TAYLOR POINTE SUBDIVISION,

UNIT TWO

APPLICATION NUMBER 22 DATE October 4, 2012
APPLICANT Taylor Pointe Subdivision, Unit Two
REQUEST Subdivision

DETAIL SITE PLAN

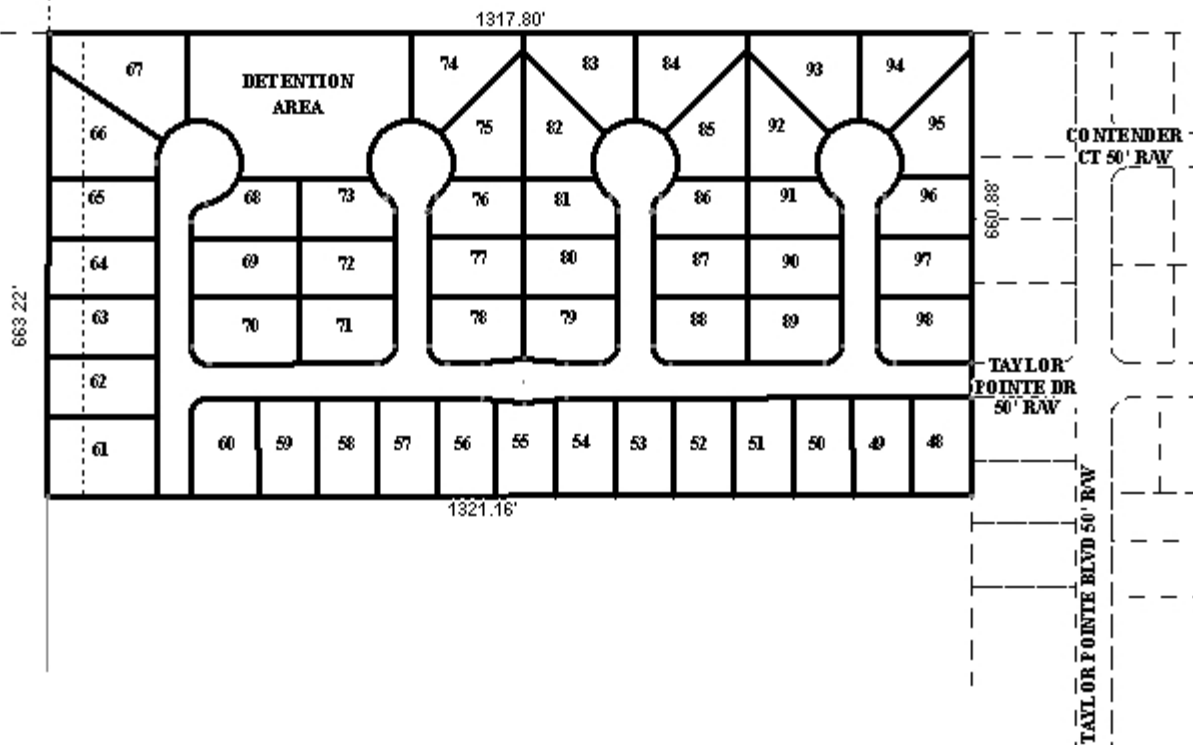
The purpose of the application is to create 51-lots of record from one metes and bounds parcel. The plat labels the size of each lot in square feet, and all lots meet the minimum size requirements of Section V.D.2. of the Subdivision Regulations. This information should remain on the Final Plat, or a table should be provided depicting the same information.

There is a note on the preliminary plat stating that there will be 25-foot minimum building setbacks as required per Section V.D.9. of the Subdivision Regulations, however, the building setback line is required to be illustrated on the Final Plat.

The site involves the creation of new streets which must be constructed and dedicated to County Engineering standards, including a street stub to the South. Most of these streets are short cul-de-sacs. The one main road is approximately 1200 feet long and straight, and would therefore require calming devices; the only kind of calming device that the County will accept is a traffic circle. Based on the length of the street, it is recommended that the main street feature one traffic circle as proposed; however, as proposed the street is illustrated as having a bump out, the developer should create an island illustrated as common area. However, the suitable location for this circle, and its size, location and design will ultimately be subject to County Engineering approval.

It should be noted that the Taylor Pointe Subdivision, Unit One provides a street stub to the adjacent property to the North. Due to the large size of the adjacent property, a street stub should be provided in the approximate location as the currently proposed detention area. A similar condition was required for the original Hamilton Woods Subdivision in 2006.

In addition, as a means of access management, a note should be placed on the Final Plat limiting each lot to one curb cut each, with the size, design and location to be approved by County Engineering and conform to AASHTO standards.

The plat illustrates a large detention area, therefore, all common and detention areas should be labeled and a note placed on the Final Plat stating that maintenance of common and detention areas will be property owners' responsibility.

- 1) the provision of one traffic circle on Taylor Pointe Drive with the size, location, and design be approved by Mobile County Engineering and conform to AASHTO standards;

- 2) the provision of a street stub to the adjacent property to the North with the size, location, and design be approved by Mobile County Engineering and conform to AASHTO standards;

- 3) the placement of a note on the Final Plat stating that all lots are limited to one curb cut each, with the size, design and location to be approved by Mobile County Engineering and conform to AASHTO standards;

- 4) the labeling of all common and detention areas and the placement of a note on the Final Plat stating that maintenance of common and detention areas will be property owners' responsibility;

- 6) illustration of the 25' minimum building setback line for all lots;
- 7) labeling of each lot with its size in square feet, or the provision of a table depicting the same information;
